**DEVIATION REQUEST
AND DECISION FORM**
(Judge Orr Deviation)
Updated: 6/26/2019

Project Name : Villas at Aspen Trails
Schedule No.(s) : 5509200003
Legal Description : TR IN SEC 19-15-65 DESC AS FOLS: BEG AT THE NE COR OF LEGACY HILL DR AS PLATTED IN THE TRAILS AT ASPEN RIDGE FIL. NO. 1 ALSO BEING THE SLY ROW LN OF BRADLEY RD, TH N74-20-48E 425.01 FT, TH S15-39-12E 429.99 FT, TH S74-20-48W 360.01 FT, TH ALG THE ARC OF A CUR TO THE R HAVING A RAD OF 75.00 FT, A C/A OF 60-04-25, ARC DIST OF 75.00 FT, WHICH CHORD BEARS N75-37-00W, ARC DIST OF 75.08 FT, TH N15-39-12W 392.40 FT TO THE POB

Deviation Exhibit 1
Summary of Deviation Elements
 Villas at Aspen Trails (LSC# S234390)

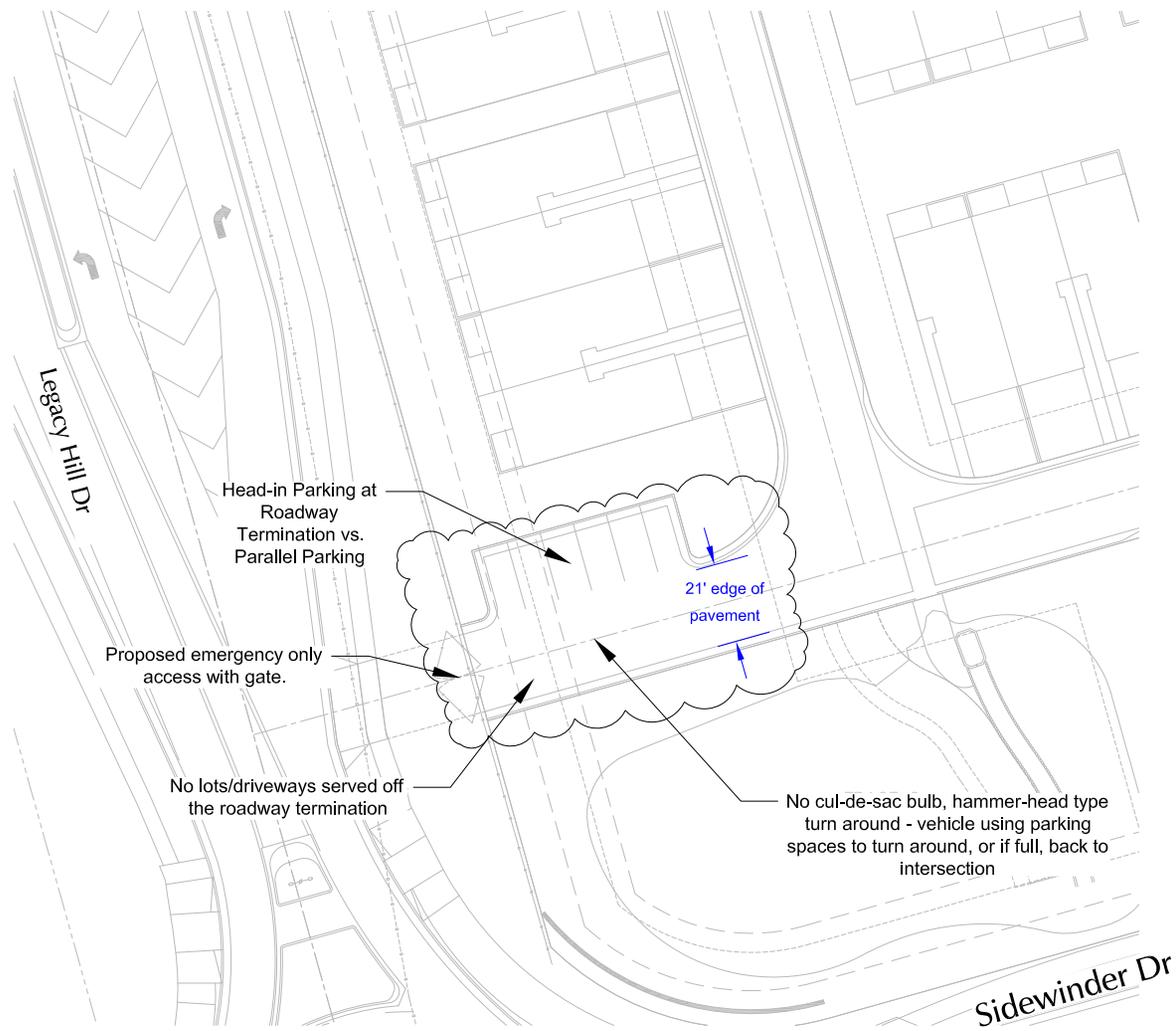
The following is a comparison between the *ECM* standard and the proposed design of the private internal street loop. These are summarized graphically in Deviation Exhibit 1.

Criteria	Urban Local (Low Volume)	Proposed Design
Design speed	20 mph	15 mph
Posted speed	20 mph	15 mph
Lane width	12'	10.5'
Right-of-way	60' (w'5' easements)	N/A
Paved width	24'	21'
Sidewalk width	5' attached	No Sidewalks
Parking permitted	Yes	No*

Access Clearance from Intersections - Residential. Several individual unit driveways for corner units are shown closer than the *minimum of 10 feet from the point of curvature or point of tangency of the curb line at the intersection*. These are noted on **Deviation Exhibits 1**. Note regarding the northeast and northwest corner intersections: These are intended as intersections, even though the north legs are only roadway stubs. Please refer to **Deviation Exhibit No. 3** for a detail of the northeast corner intersection.

Corner Lot Driveways closer than 10' from the point of curvature or point of tangency of the curb line at the intersection.

Deviation Exhibit 2
Villas at Aspen Trails (LSC# S234390)

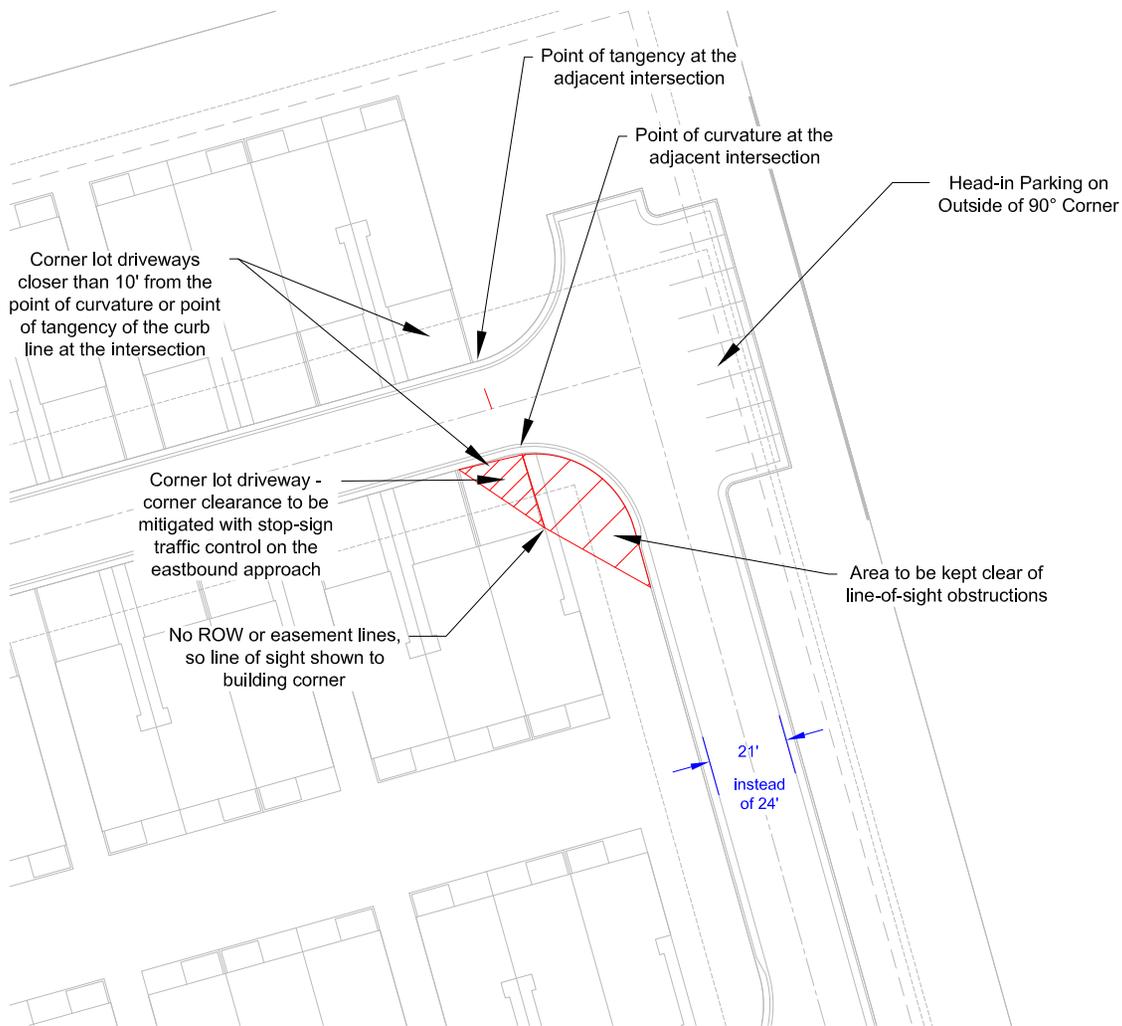
Non-Standard Roadway Termination: The proposed alternative, shown in the attached **Deviation Exhibit 2**, would modify the elements of standard roadway termination as shown. A copy of the *ECM* Urban Local roadway termination (SD_2_77) is also attached for reference. The standard plan sheet shows several standard dimensions, including the curve data for successive arcs which form the cul-de-sac "bulb". The proposed design shows the street segment extending to the emergency access gate, with parking spaces on the north side, forming a "hammerhead" type design.

Proposed Roadway Termination Design* vs. Standard Cul-de-Sac

*Connects to emergency-only access

Deviation Exhibit 3
**Corner Lot Driveway Detail -
 Clearance from the Intersection**

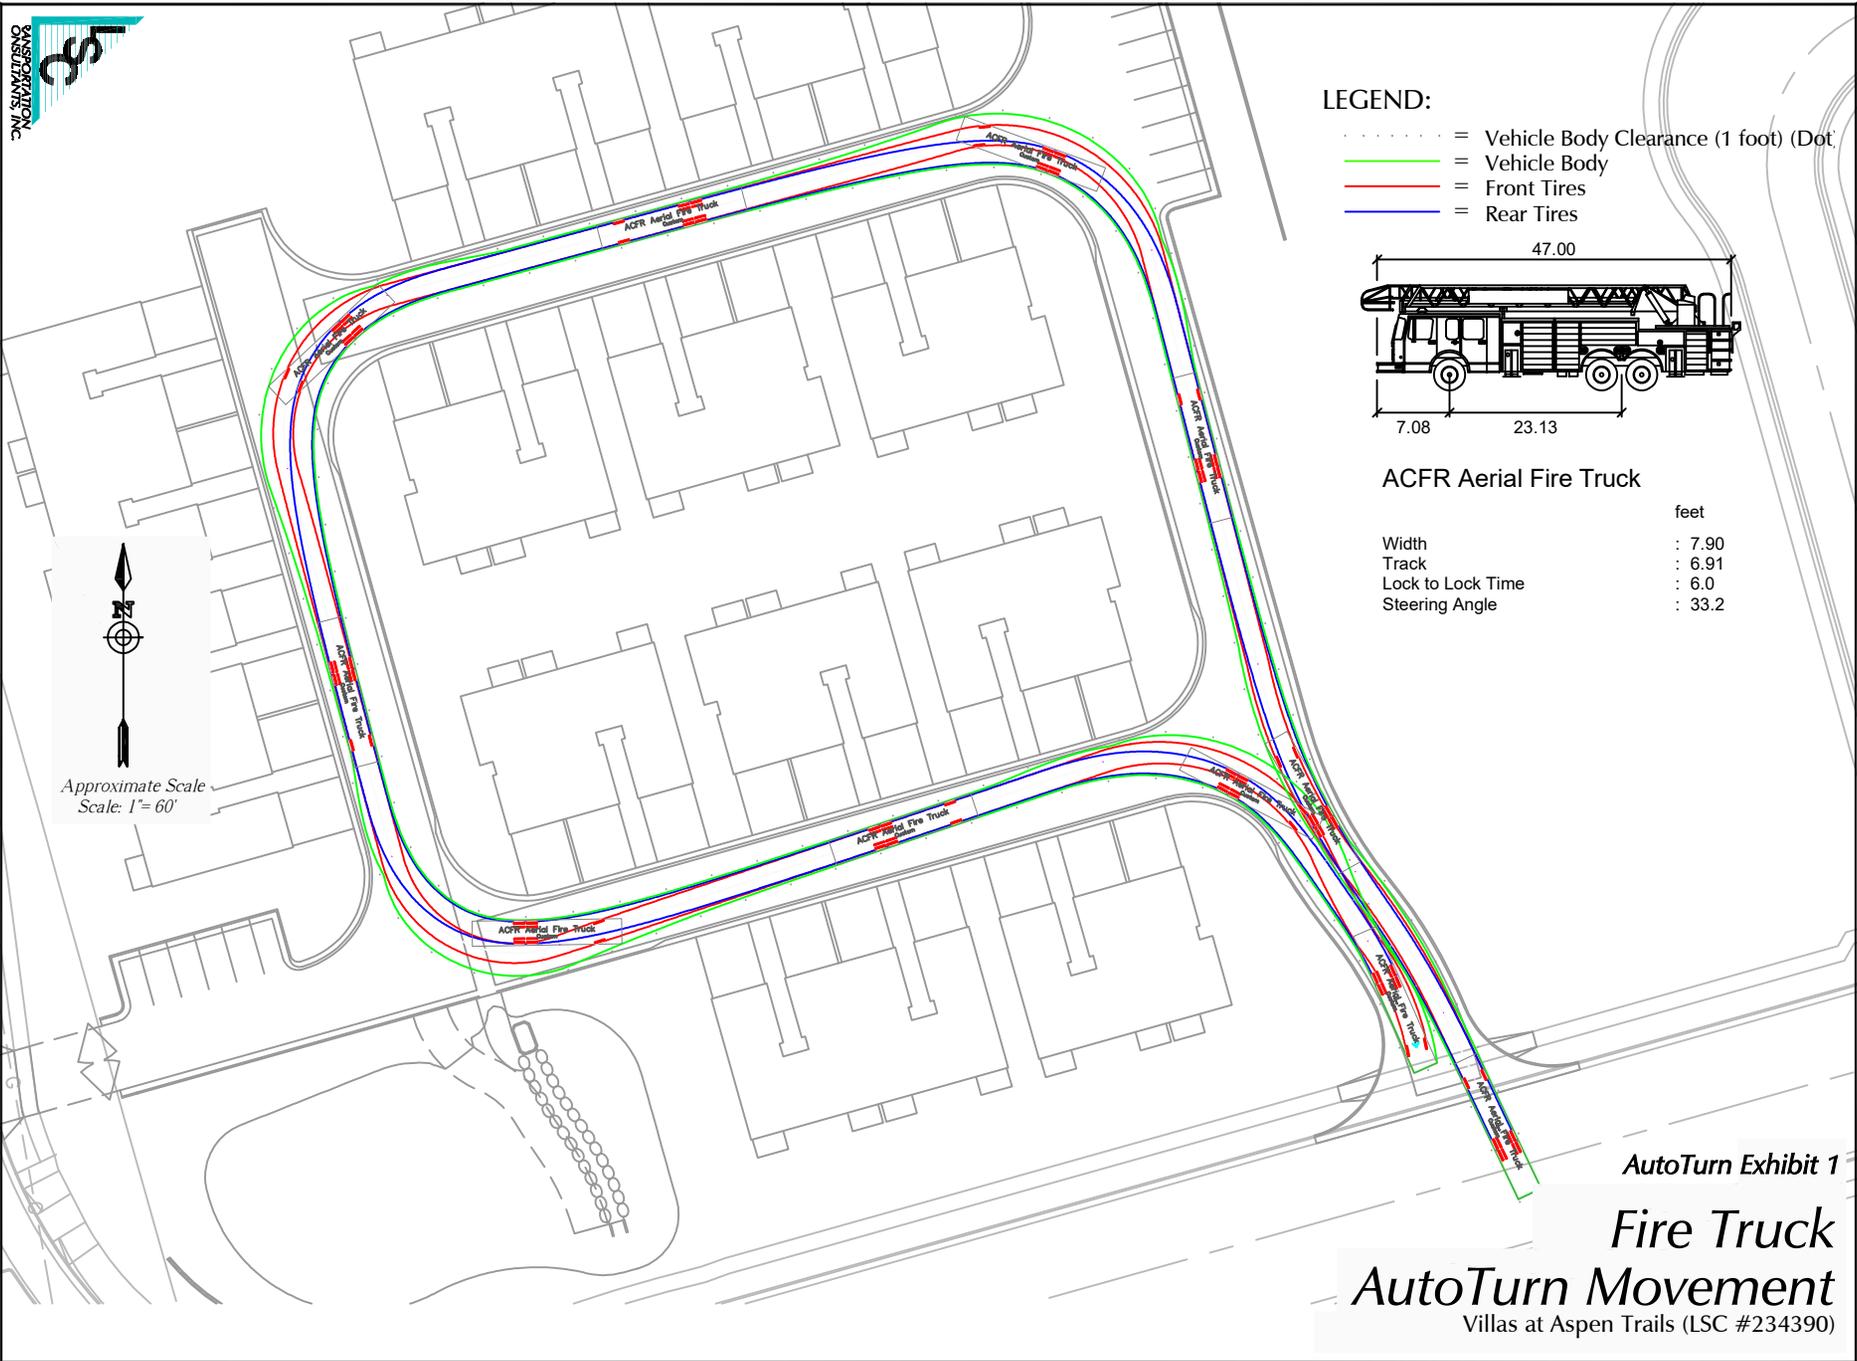
The Access Clearance from Intersections - Residential deviation is needed as several corner lot driveways do not meet the criteria in *ECM* section 2.4.1.F.1, which states that access to residential corner lots shall be located a minimum of 10 feet from the point of curvature or point of tangency of the curb line at the intersection. As noted above, the northeast and northwest corner intersections are intended as *intersections* even though the north legs are only roadway stubs. The applicant intends to utilize stop signs as proposed as mitigation for the corner-lot driveway clearance and as the sight-distance triangles needed for uncontrolled intersections would not be available – the corner lot driveways would be within the sight triangle for what would otherwise be an uncontrolled intersection sight-triangle. Please refer to detail shown on Deviation Exhibit 3.
